ADDENDUM #2

Roof Renovation Project
Manchester Regional Academy
Manchester, CT
Reference #2017-031A

June 25, 2019

SHEET NO.
SKA2.1

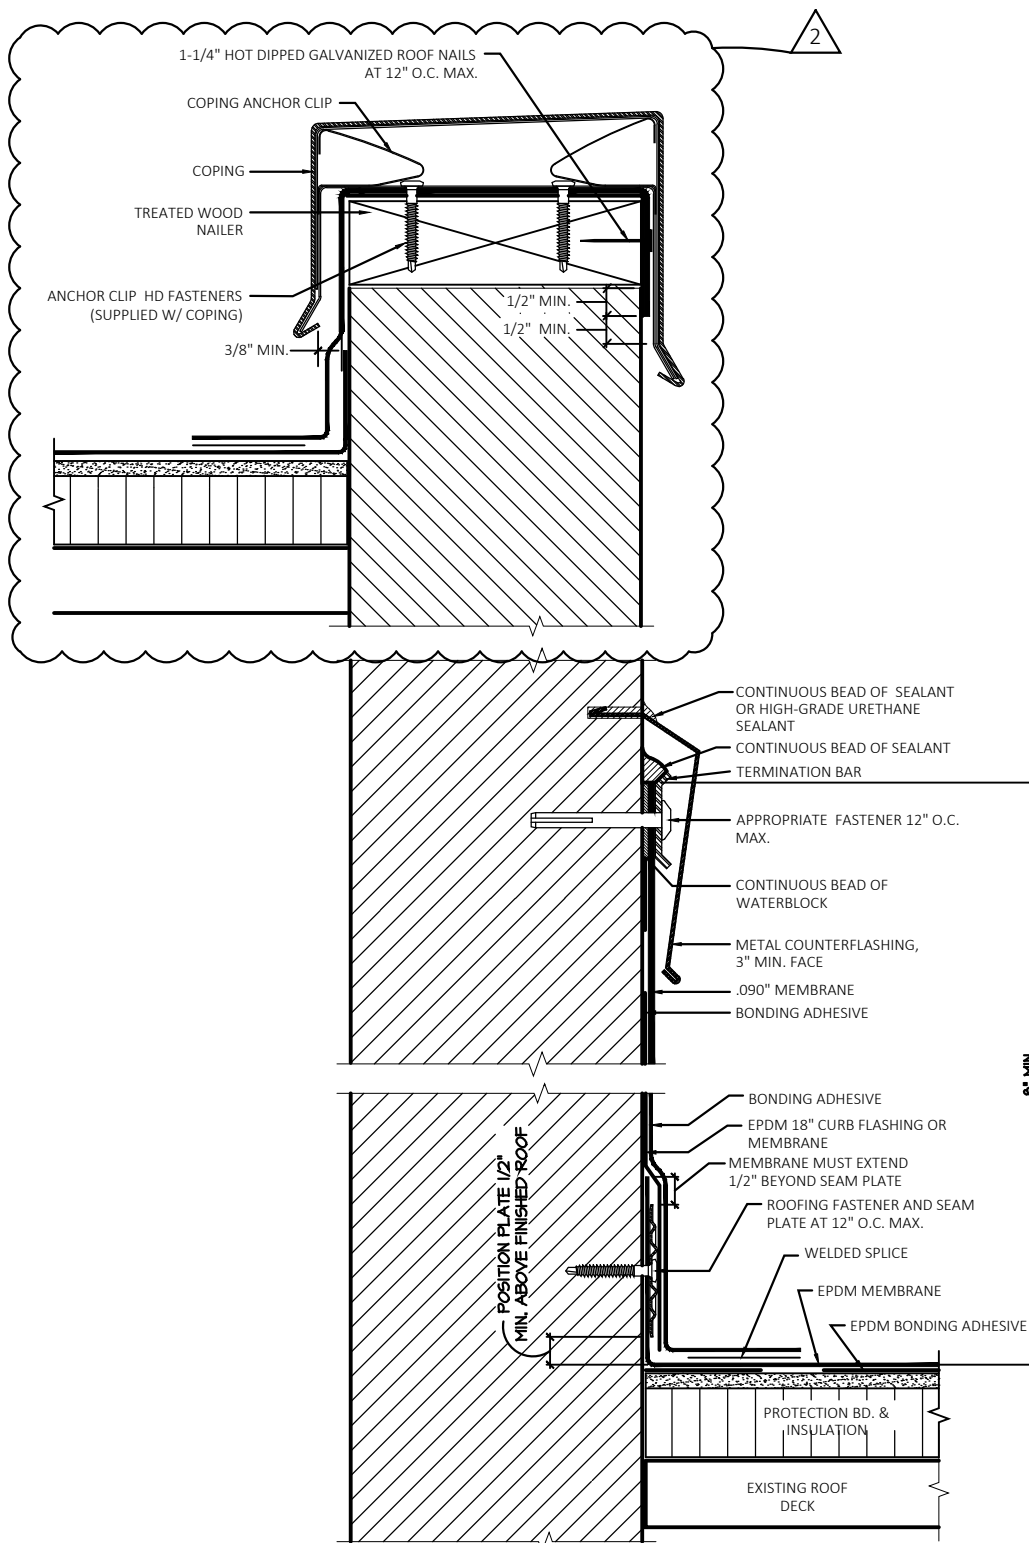
a. Standard colors
6. Are all Exhaust Fan Curbs to be removed and replaced? Key Note #6 on A1.1 states that the EF is to be removed and salvaged for reinstallation and the curb and associated framing is to be removed and replaced. This is further noted as (Typical), however the call out only points to (1) EF. Does this apply to everything labeled EF? If so, can a detail be provided of the intended EF curb construction?

A2.1 – Roof Construction Plan Provide installation at all fan curbs per the attached SKA2.1.
1/A3.1 – Revise detail per attached SKA2.2

a. All Exhaust Fan Curbs to be removed and replaced; refer to attached SKA2.1.
7. There is a discrepancy between the Demo Plan and New Roof Plan in regards to the RTU curbs. The demo plan calls out that all (3) are to have their curbs replaced... the new roof plan calls out that one of the RTU's (nearest the roof hatch) is to have the curb removed and put on sleepers?

SHEET NO.
SKA2.2

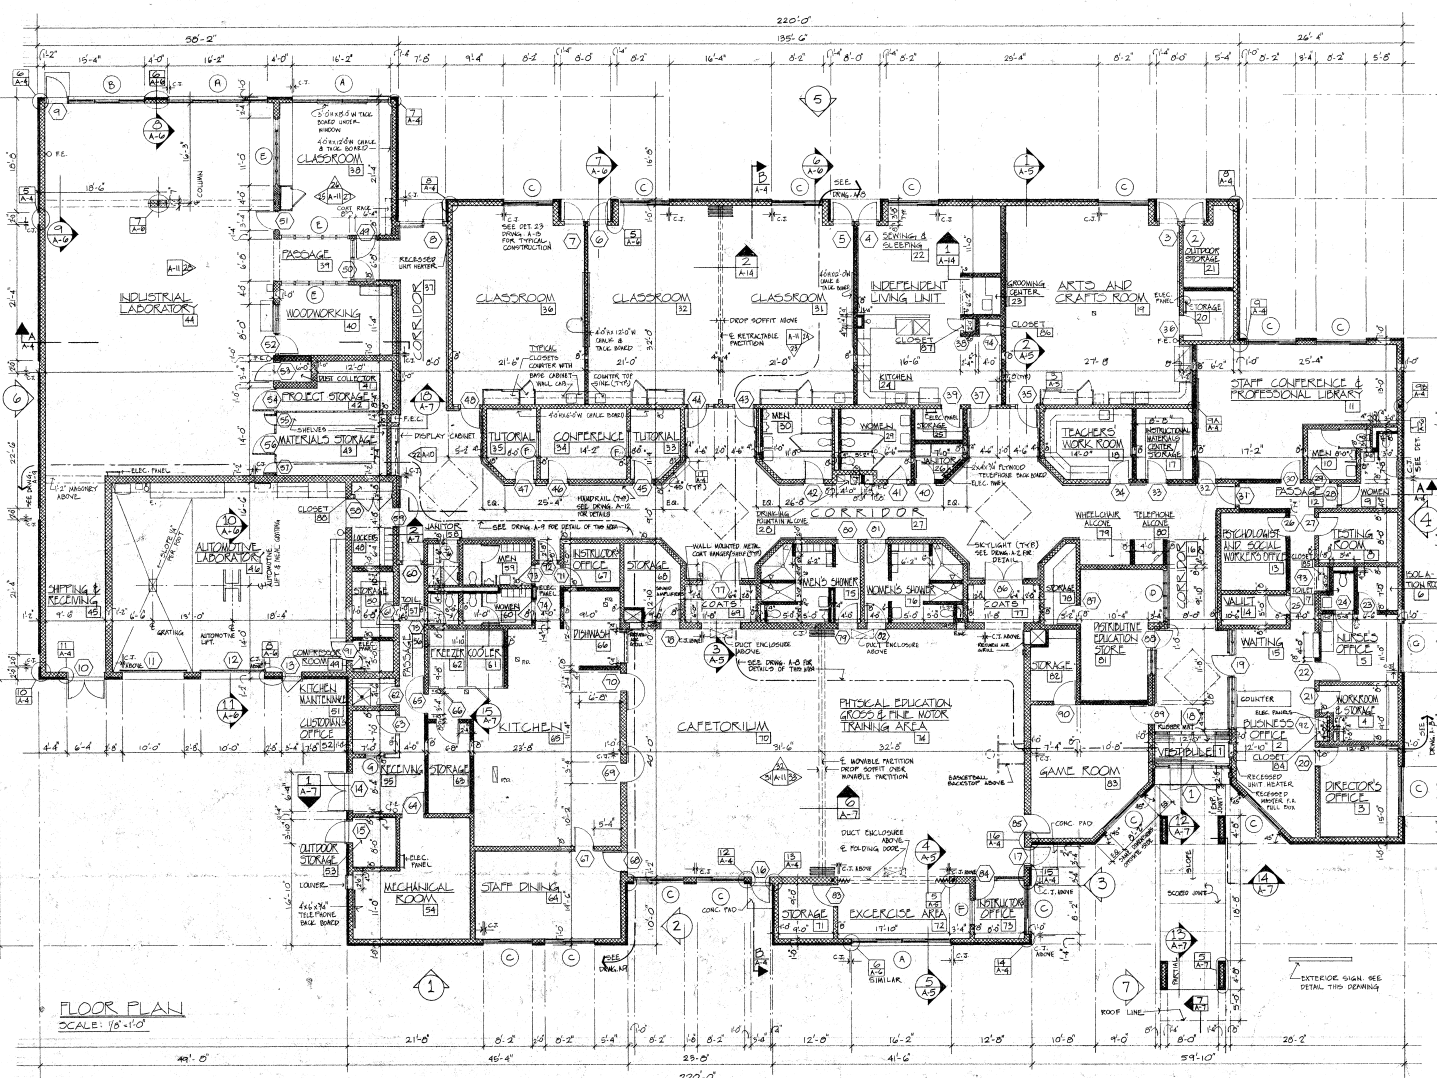
a. These are not parapet walls nor new constructions; provide typical Roof Edge Detail.
4. Detail 1/A3.1 depicts both the coping cap and a saw-cut reglet. Please advise as to the intent of the high roof parapet with coping cap.

a. Refer to attached SKA2.2
5. Please clarify the color for both coping and edge gravel stop. The spec says to be selected from manufacturers full range. Due to pricing difference, is this to be from full range of standard -or- custom colors?
